GRUNDIG

**SERVICE
INFORMATION
BULLETINS
1999**

Service Information

Product **RR 430 CD**

Figure 1

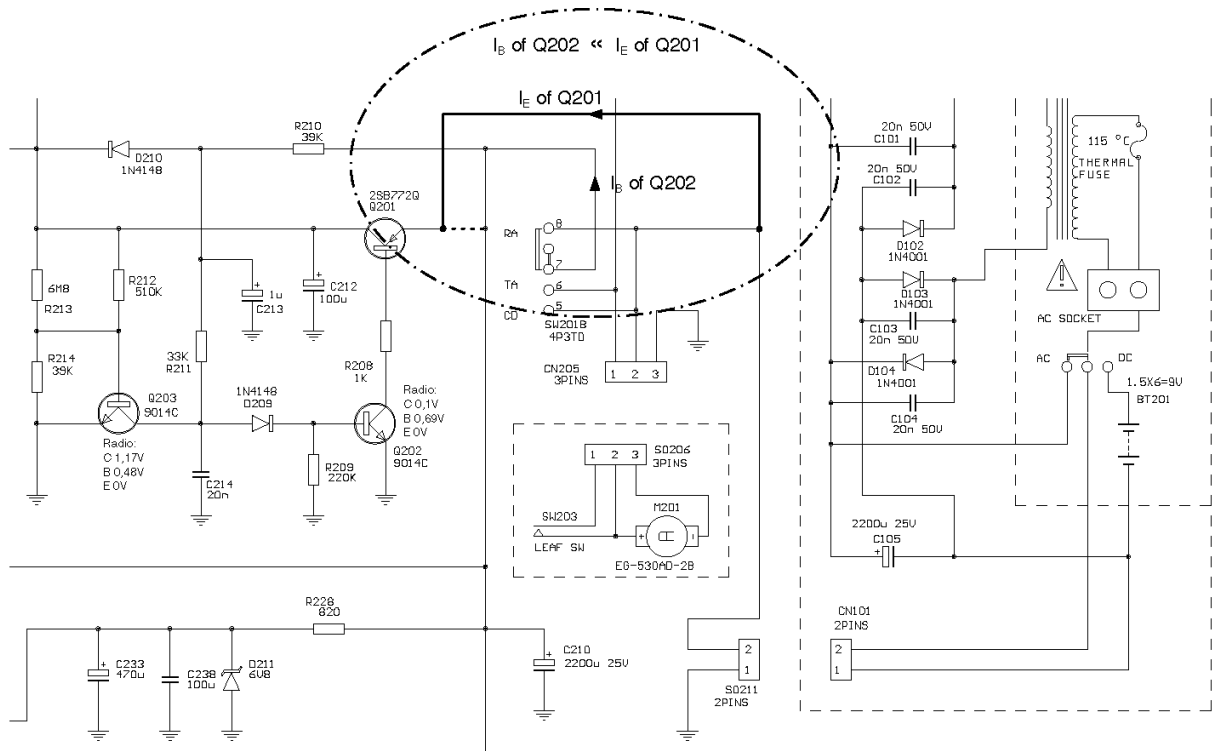
The contacts (7-5) of switch SW 201B become charred so that they do no longer contact.

The switching contact provides the voltage for both the CD servo system and the audio power amplifier.

Connect the emitter of Q 201 directly to the voltage supply. The switch is only used for controlling the base current which is much lower than the emitter current. Fig. 1 (see page 2)

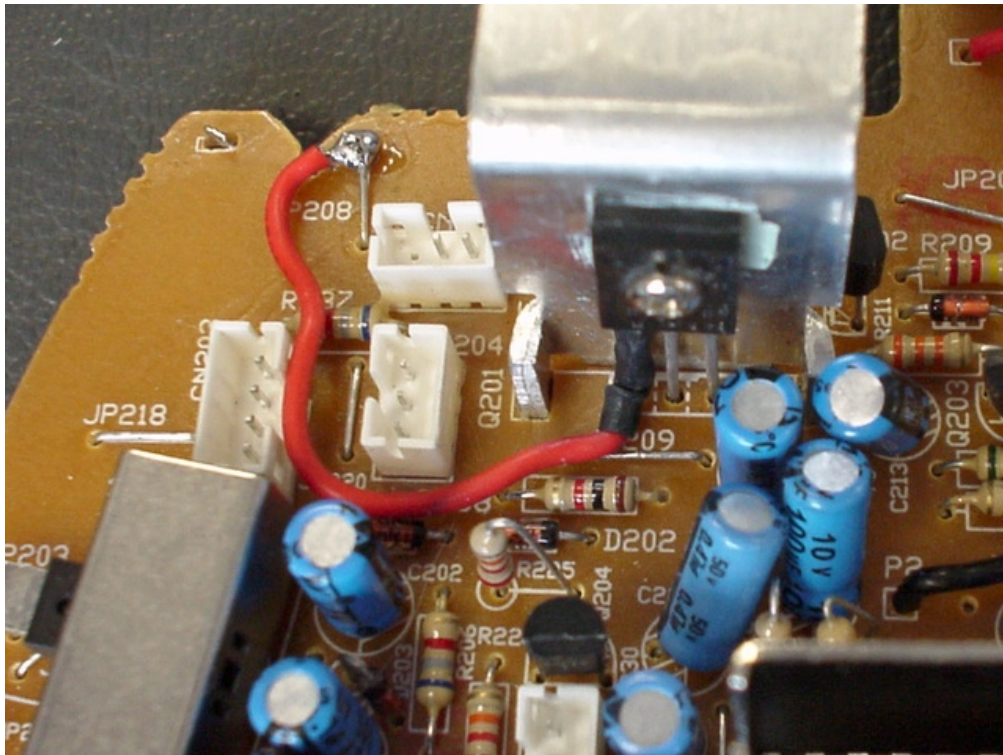
For repair: Fig. 2 (see page 2)

- Replace the slide switch.
- Disconnect the emitter of Q 201 from the circuit board using a wire cutter (or soldering iron).
- Solder a stranded wire (length=50 mm) to the emitter of Q 201 and insulate the solder joint with a piece of tube.
- Solder the other end to the jumper JP 208.
- Check the radio receiver and re-assemble it.

Changed version of DVD Player GDV 100 D

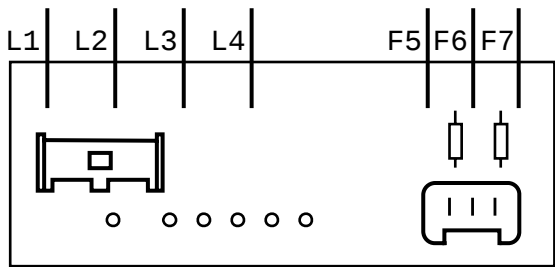
Both versions of the GDV 100 D Player are identifiable outside only by the label (on the rear side).

The two versions of the GDV 100 D Player work internally with different operating voltages. This is especially critical because the modules of both versions fit mechanically into each other.

When replacing modules take care to use only the appropriate modules for the version.

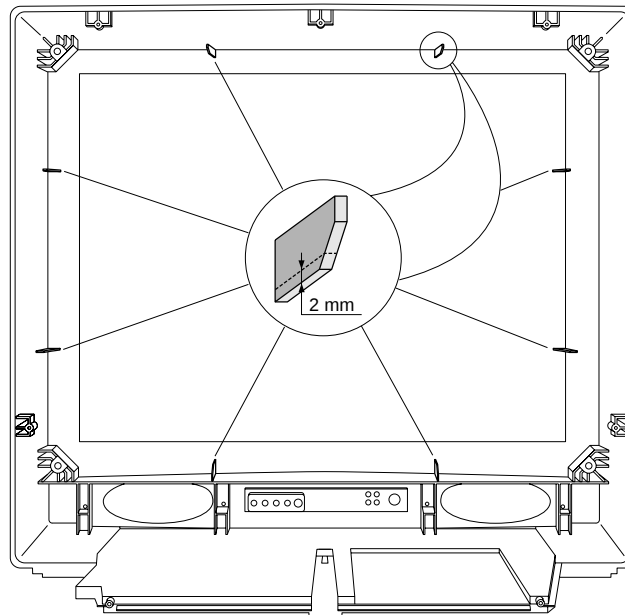
Pronounced rattling noise.

1. Magnetic radiation from the deflection yoke to the AF branch circuit.
2. The line interference suppression chokes may be in contact with the metal screen causing vibrations.

Change the following resistors within the AF output stage:

Picture tube	CR 40013 (0805)	CR 40023 (1206)	CR 40012/ CR40022(0805)
55cm (21") PHI	to 150 Ω	to 180 Ω	to 2.2 k Ω each
63cm (25") PHI	to 150 Ω	to 180 Ω	to 2.2 k Ω each
70cm (28") PHI	to 150 Ω	to 180 Ω	to 2.2 k Ω each
72cm (29") PHI	to 150 Ω	to 180 Ω	to 2.2 k Ω each
82cm (33") PHI 16:9 PHI	to 150 Ω	to 180 Ω	to 2.2 k Ω each

Unsolder the metal screen and the line interference suppression choke and insert a suppression choke with part no. 29500 834 9700. Since this choke is fitted with an additional compensating coil, the metal screen is no longer necessary.
